# Preliminary Information

## PIT5955 Buffeting / Pulsing / Vibrating / Booming / Roaring Noise Heard From C Pillar Or Rear Seat Area When Driving At Highway Speeds

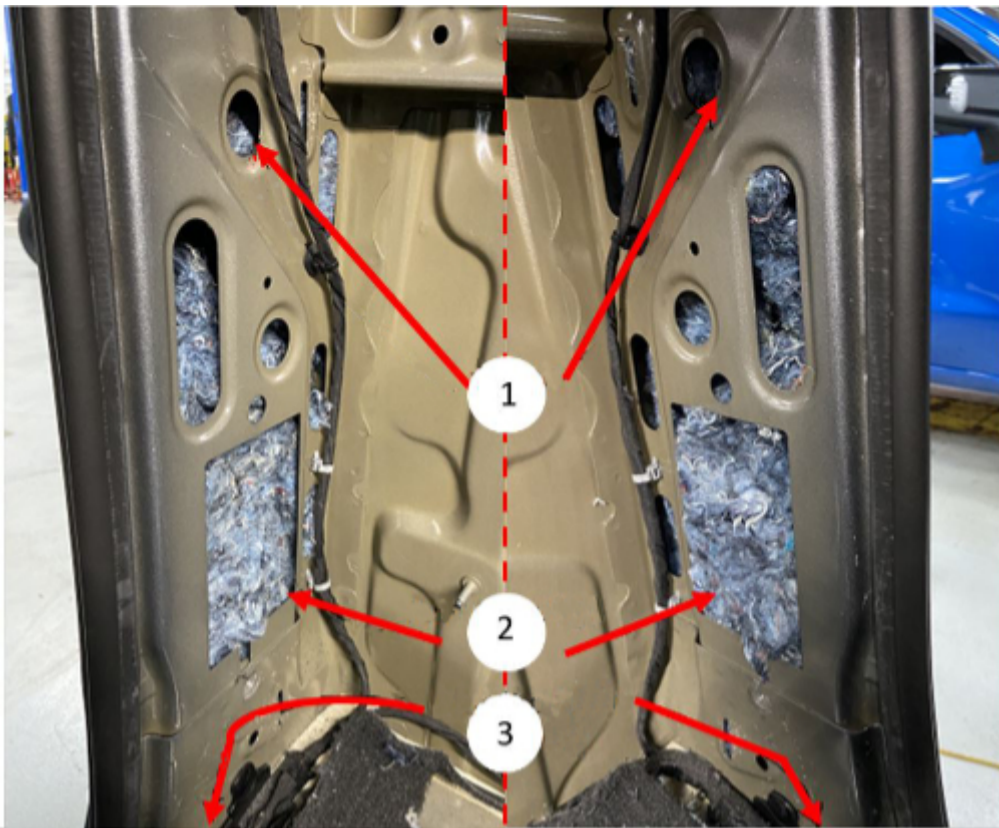
To correct this concern, fill both C pillar cavities with sound deadening material, as shown below. Obtain Echo Absorber Acoustic Panel (Natural Blend - 2"x2'x4') sound deadening material from Soundproof Cow ([www.soundproofcow.com/product/echo-absorber-acoustic-panel-natural-blend-2x2x4](http://www.soundproofcow.com/product/echo-absorber-acoustic-panel-natural-blend-2x2x4)) or other similar material. A single 2"x2'x4' sheet is enough to fill both C-pillar cavities.

1. Follow SI procedure "Body Lock Pillar Garnish Molding Replacement" to remove the C pillar trim panels.
  2. Cut the 2"x2'x4' sheet of sound deadening material into 6 1/4" by 7 1/4" pieces, as shown below.
  3. Install the cut pieces into the C pillar through the rectangular opening (2), shown above. The pieces can be compressed to fit in the opening, and once in the cavity, they will expand back to the cut dimension.
  4. Stack the pieces of sound deadening material, cut end to cut end, and fill the C-Pillar both as high as possible (1) and all the way to the bottom of the cavity as well (3).
- Note: The sound deadening material does not need to be glued in place.
5. Fill both the left and right C-Pillar cavities.
  6. Reassemble the vehicle.
